## **ADDENDUM NO. 1**

### **SRAA OFFICE EXPANSION**

SYRACUSE HANCOCK INTERNATIONAL AIRPORT  
SYRACUSE REGIONAL AIRPORT AUTHORITY  
SYRACUSE, NEW YORK

#### **IFB REFERENCE #2021-08**

**A-101**

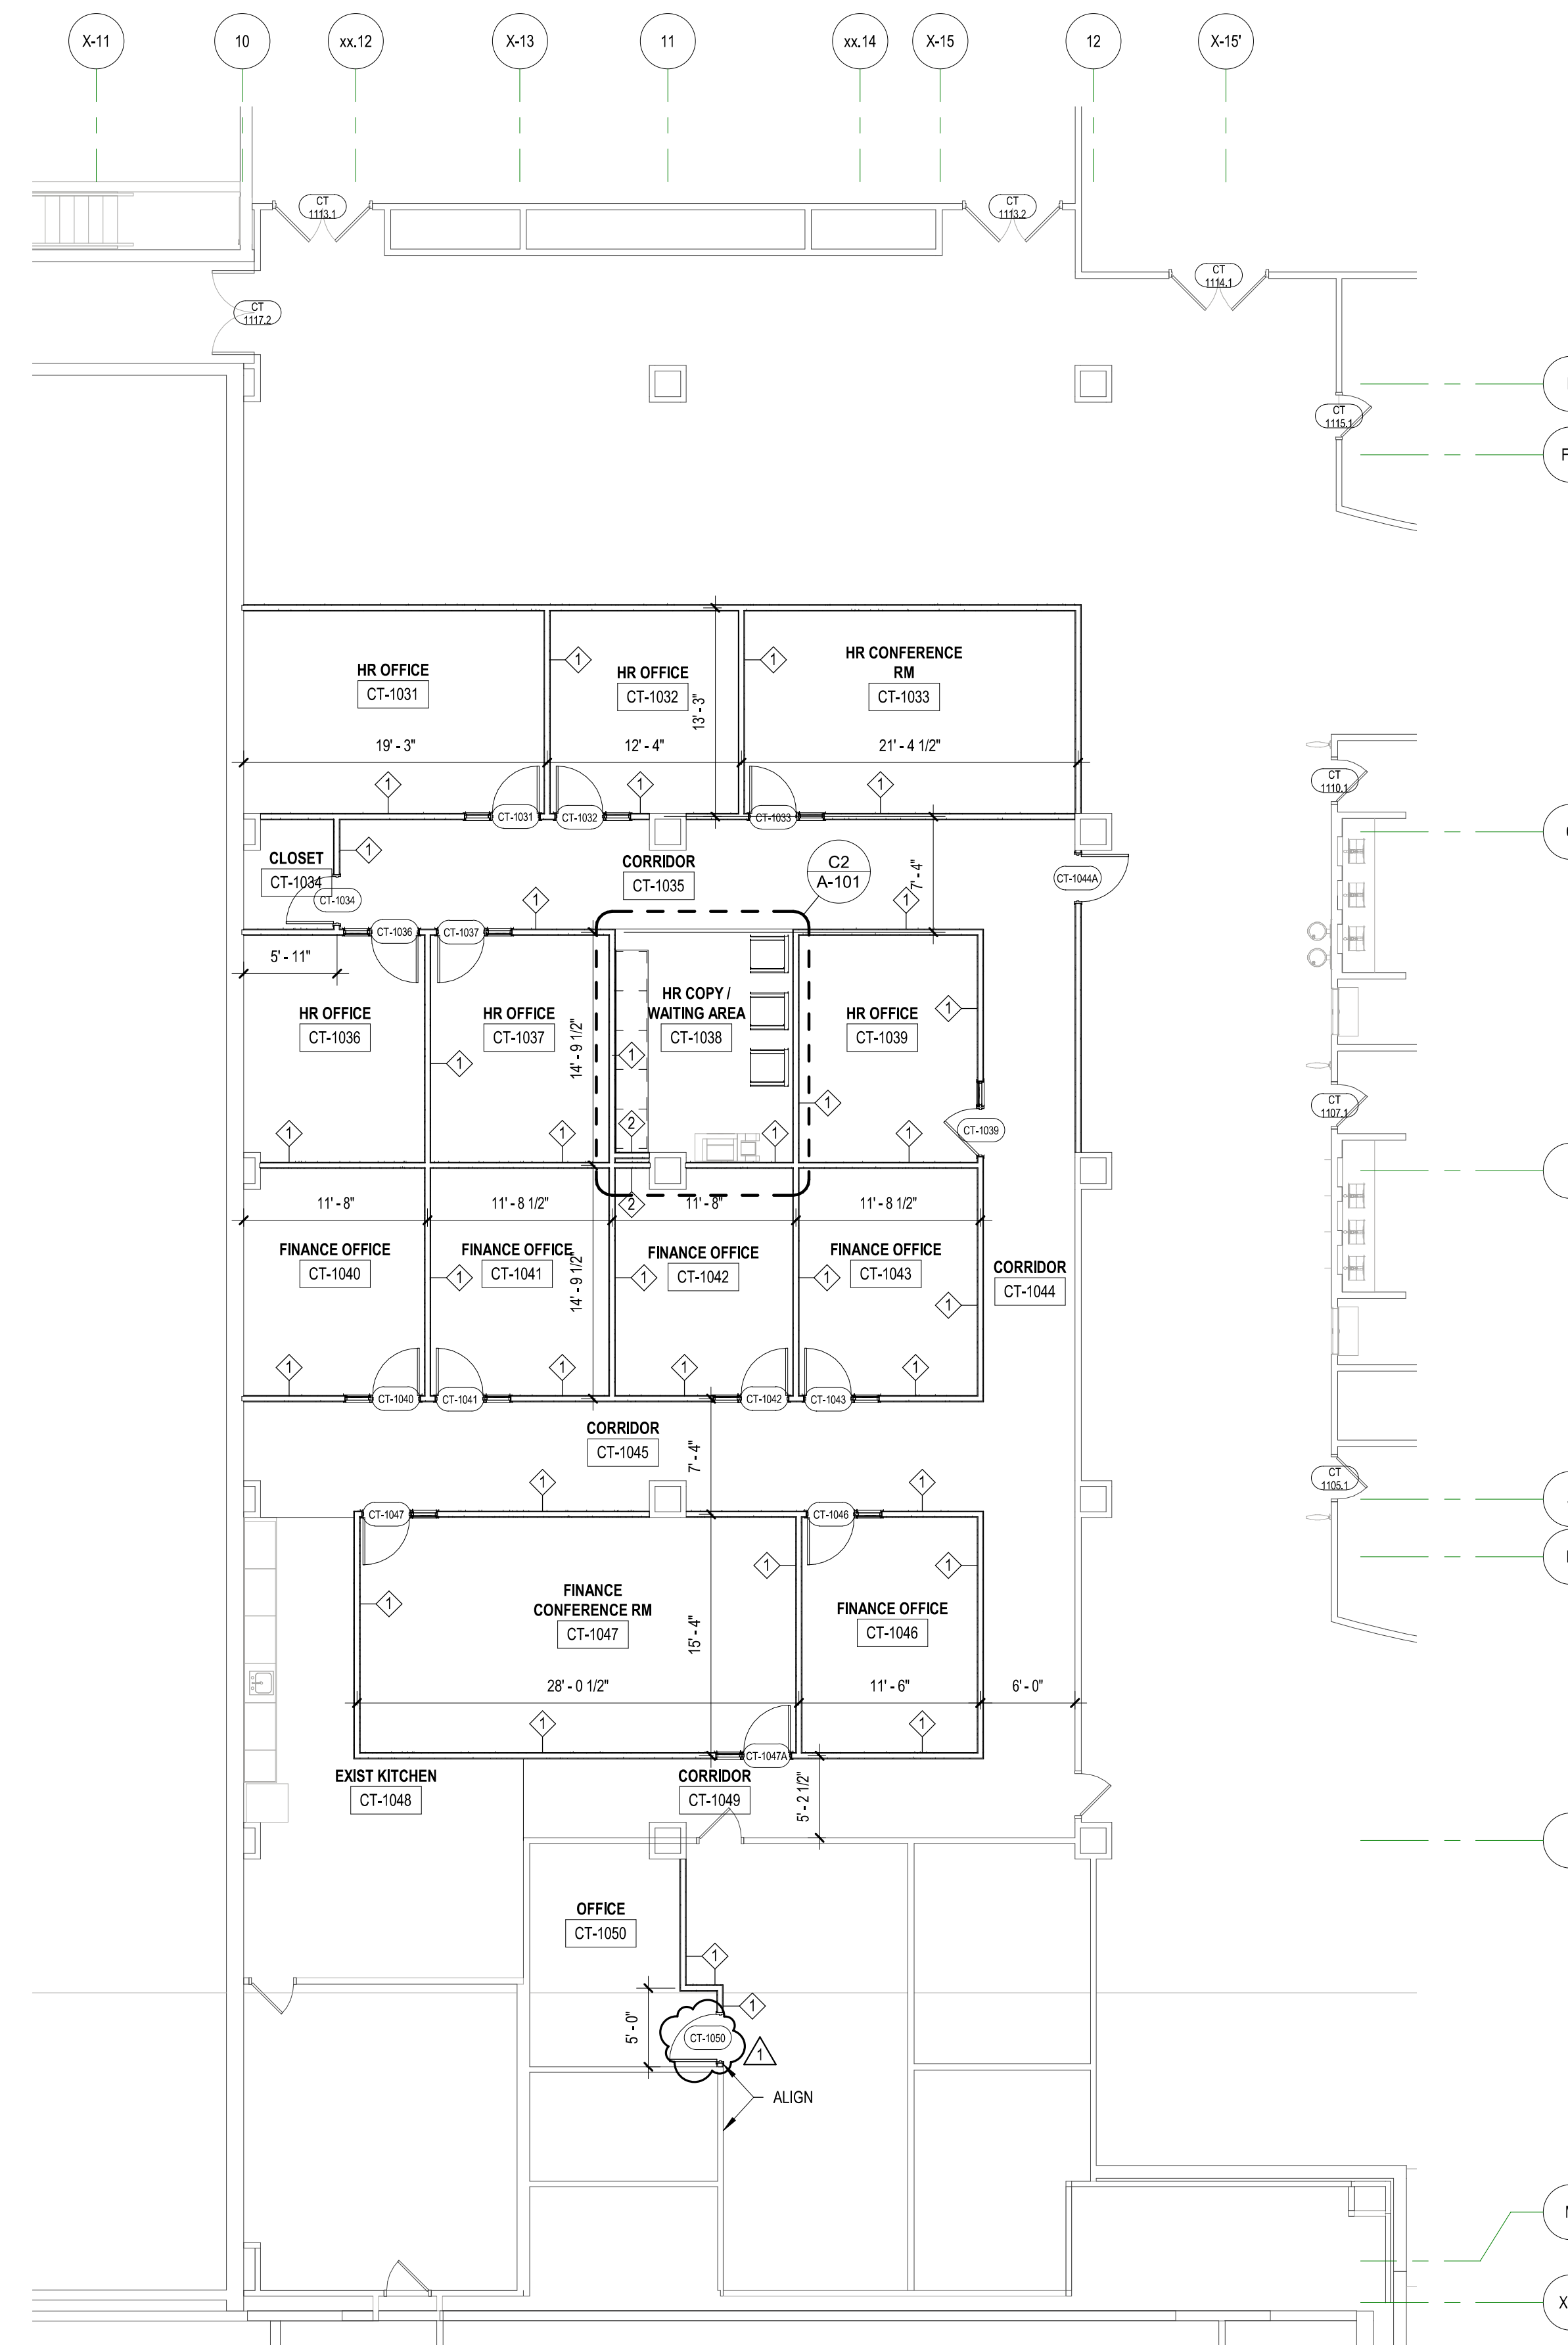
10. **REMOVE** A-101 in its entirety, and **SUBSTITUTE THEREFORE** with attached A-101 Revision 1 dated November 23, 2021.
11. **REMOVE** A-601 in its entirety, and **SUBSTITUTE THEREFORE** with attached A-601 Revision 1 dated November 23, 2021.

**B2** HR COPY / WAITING AREA - ELEVATION  
 SCALE: 1/4" = 1'-0"

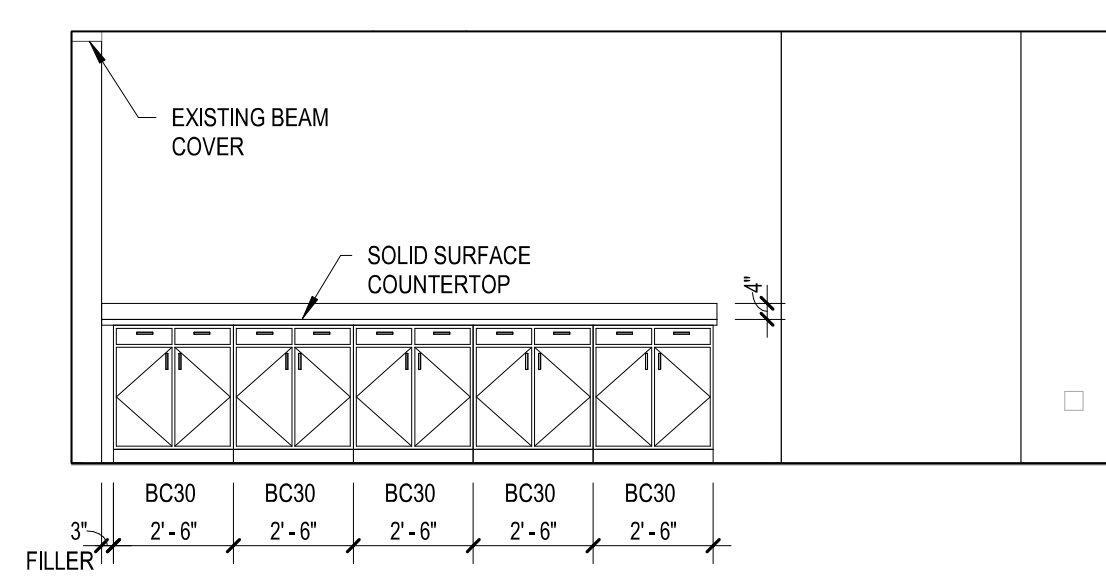
6.	<p>Request for Clarification:</p> <p><i>Detail B2.A-101 shows base cabinets labeled BC30. Please provide a section through this BC30 showing any shelving, etc.</i></p>	<p>Provide one adjustable white melamine shelf in each base cabinet.</p>
